**TAMPA-HILLSBOROUGH COUNTY
EXPRESSWAY AUTHORITY**

Addendum No. 3

Renovation Services ~ THEA TMC

RFP O-01120

Proposed Phasing Plan – Bid Alternate No. 4
March 31, 2020 - Revised 8/28/2020

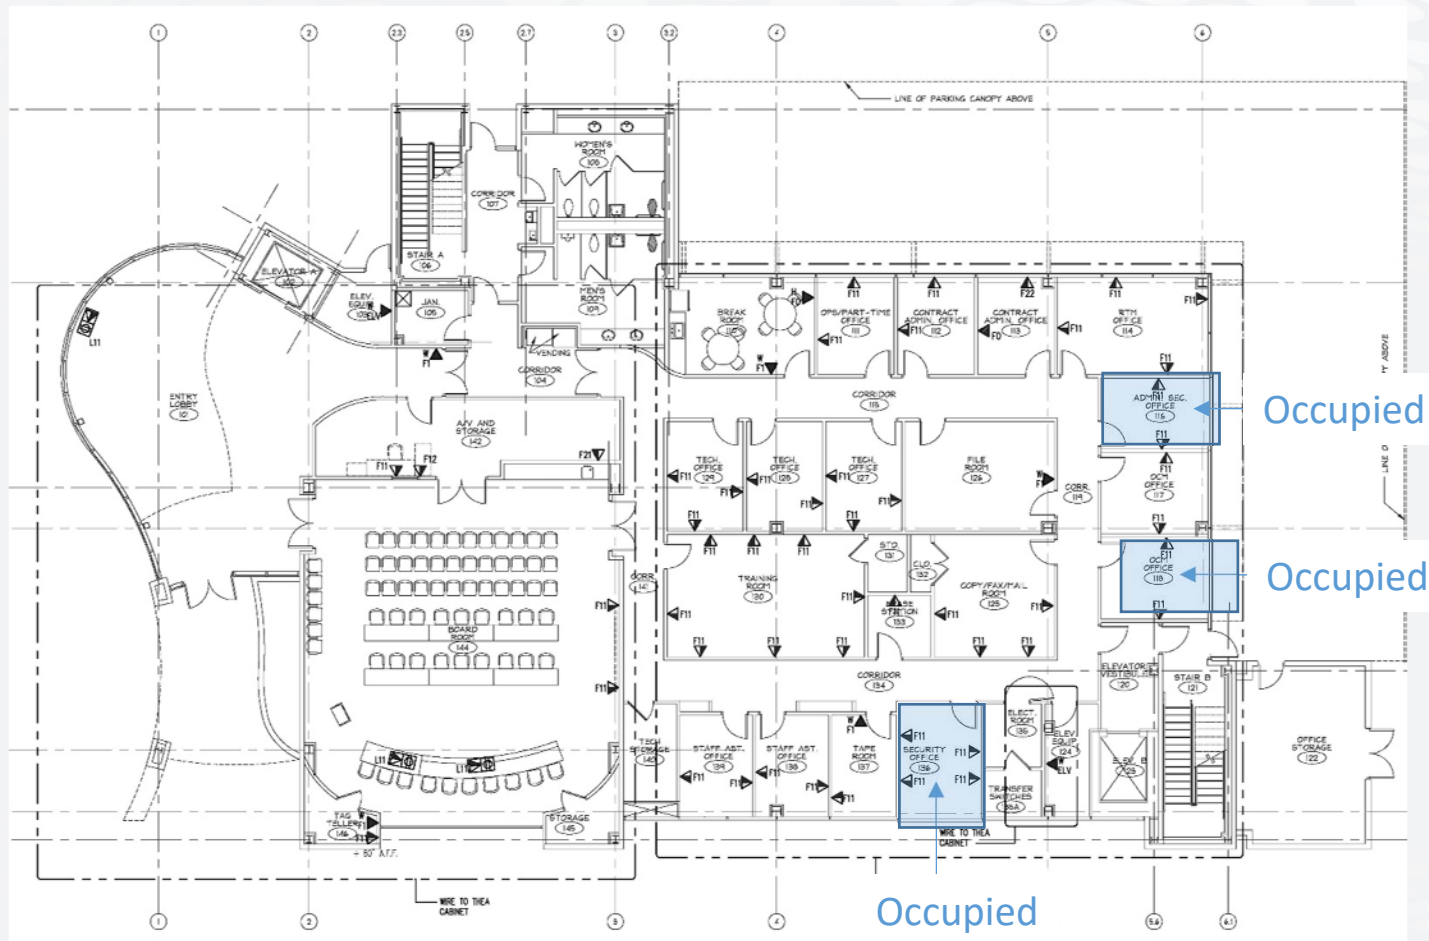
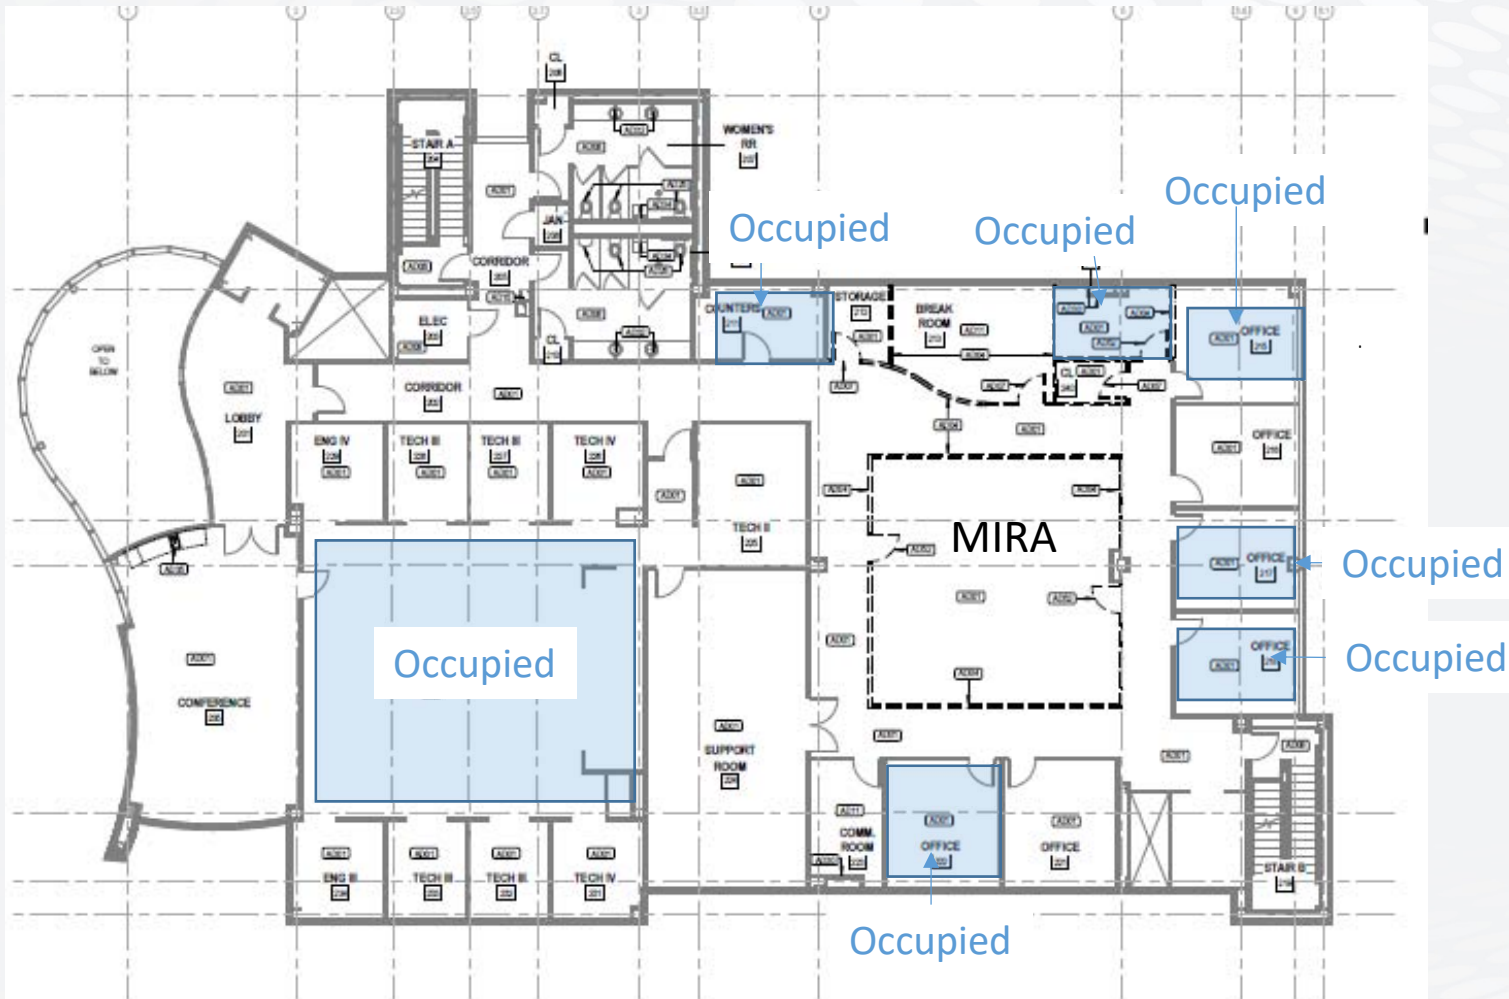
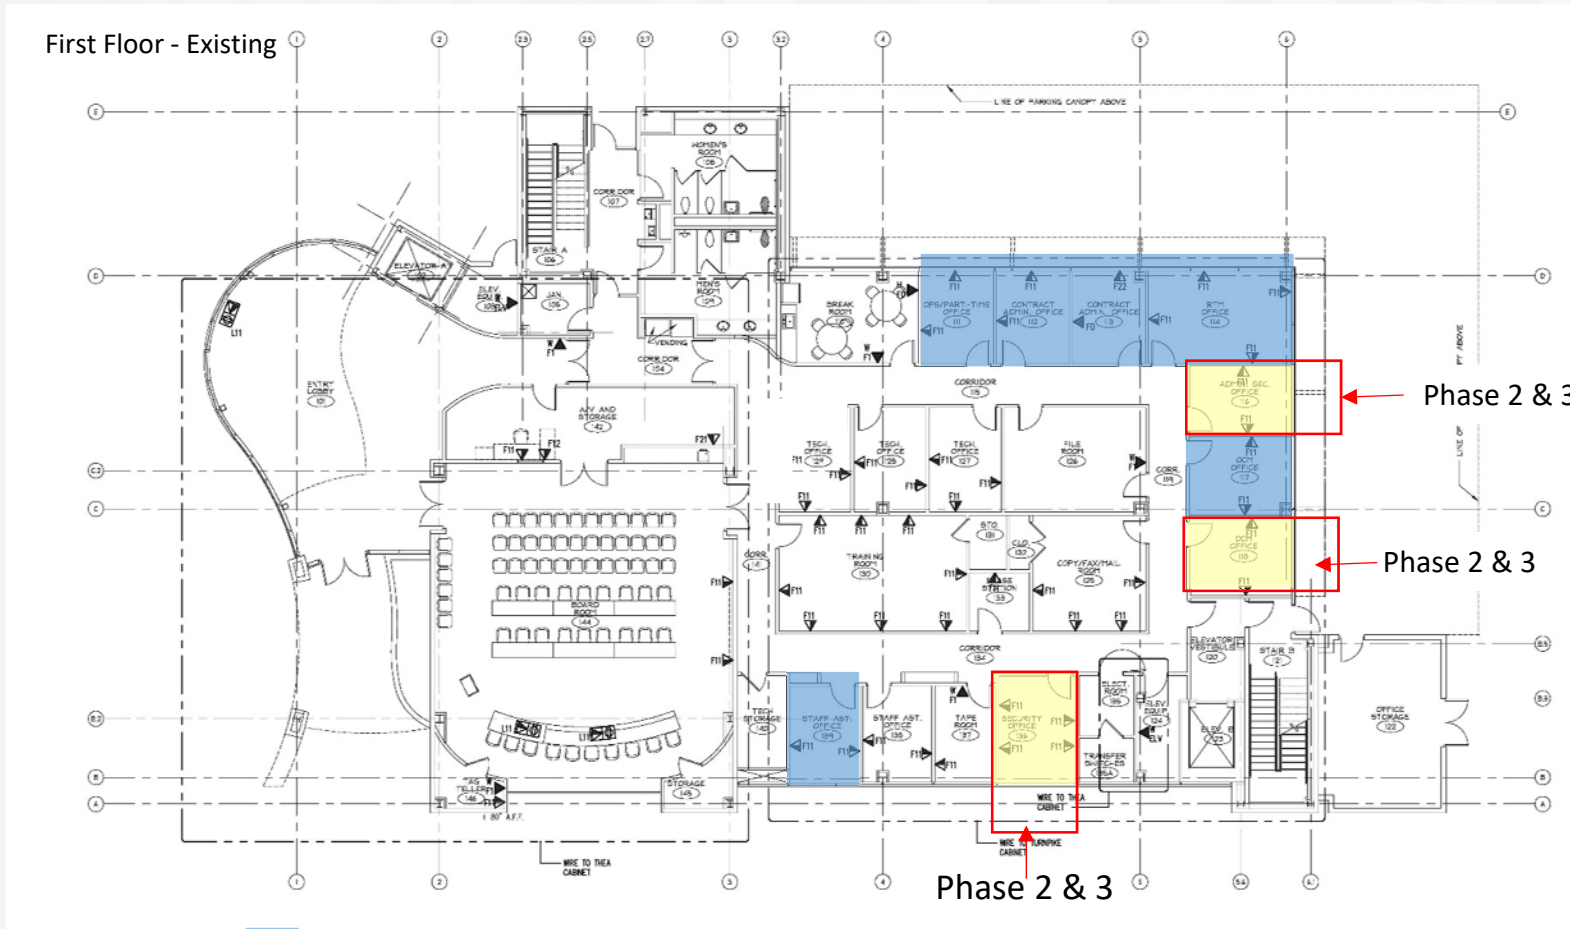
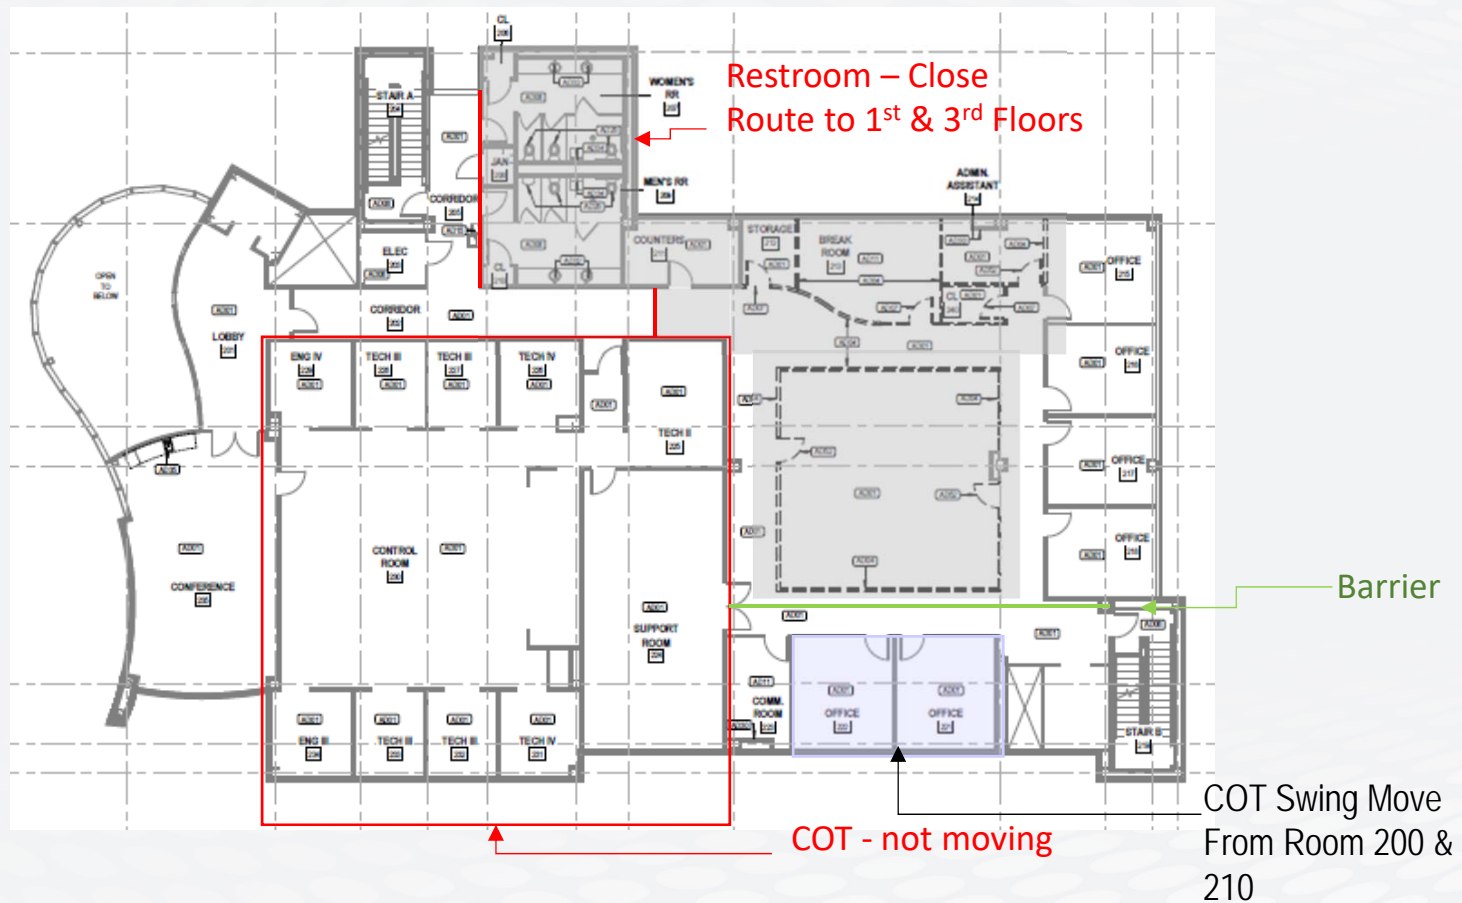
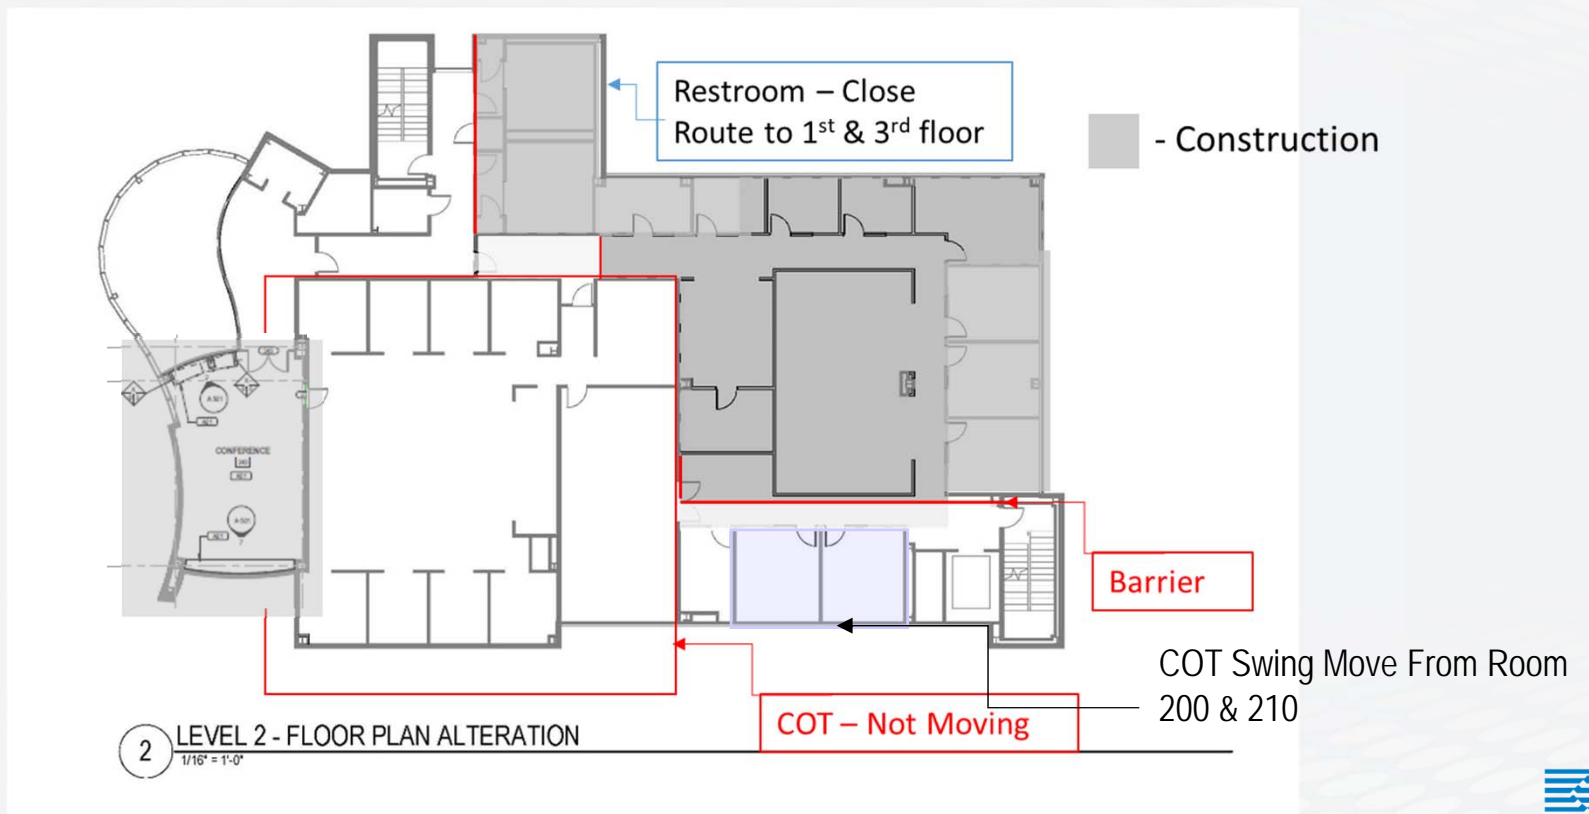
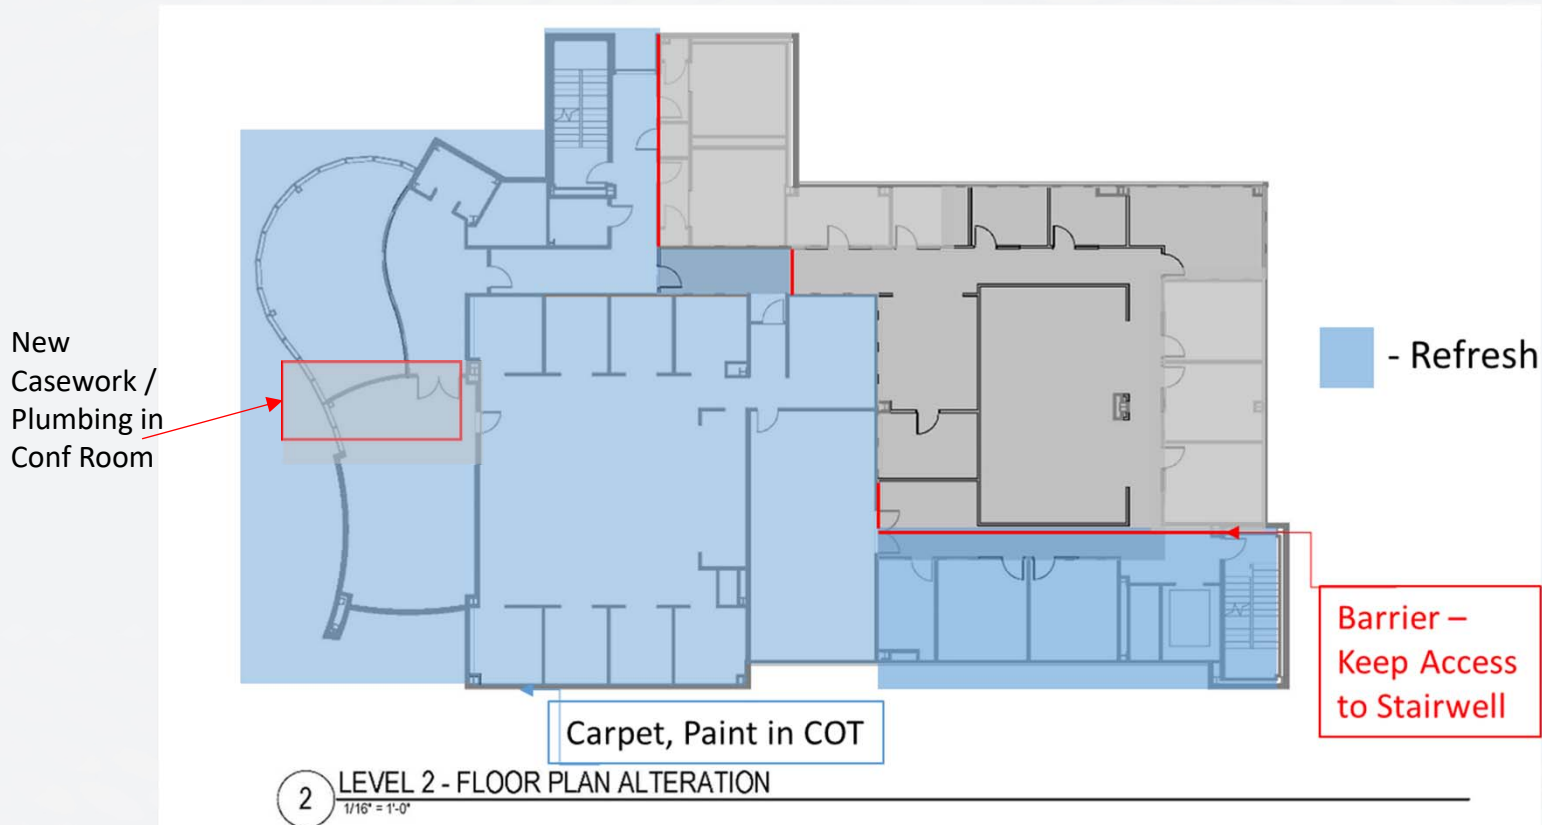
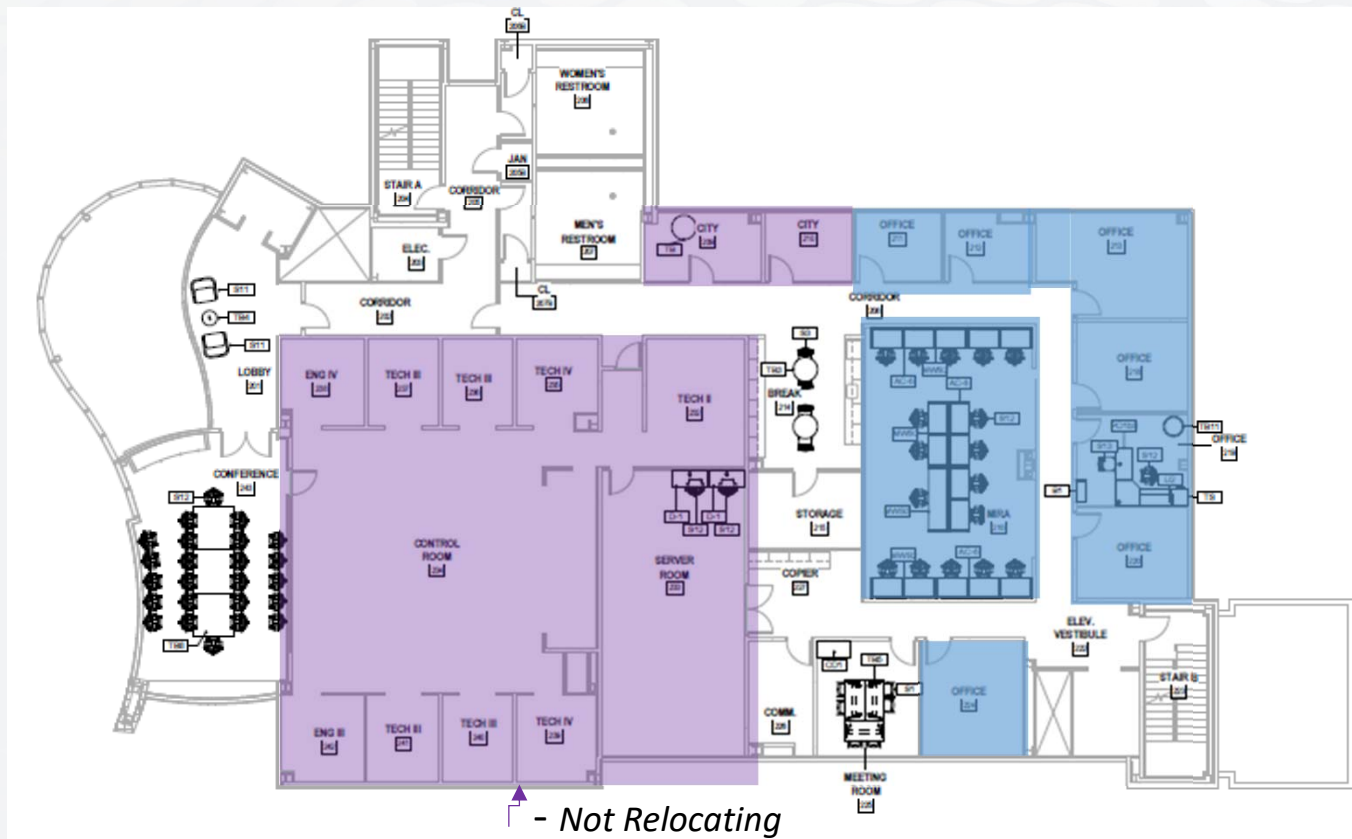
Alternate No. 4: Revised phasing plan to include staged access to the 2nd and 3rd floor renovation areas sequentially.

Response 70:	That is correct. Base bid assumes that the contractor would have access to perform work on all floors simultaneously. Schedule, means and methods are up to the contractor with some limitations regarding the TMC, server rooms and the like, which must remain in operation. The alternate 4 would require phasing of the renovation one floor at a time, likely beginning with the 2nd floor, then 3rd floor with 1st floor last. The first floor would be used as temporary "swing space" to accommodate THEA personnel during phased renovations. See Phasing Plan included with this Addendum
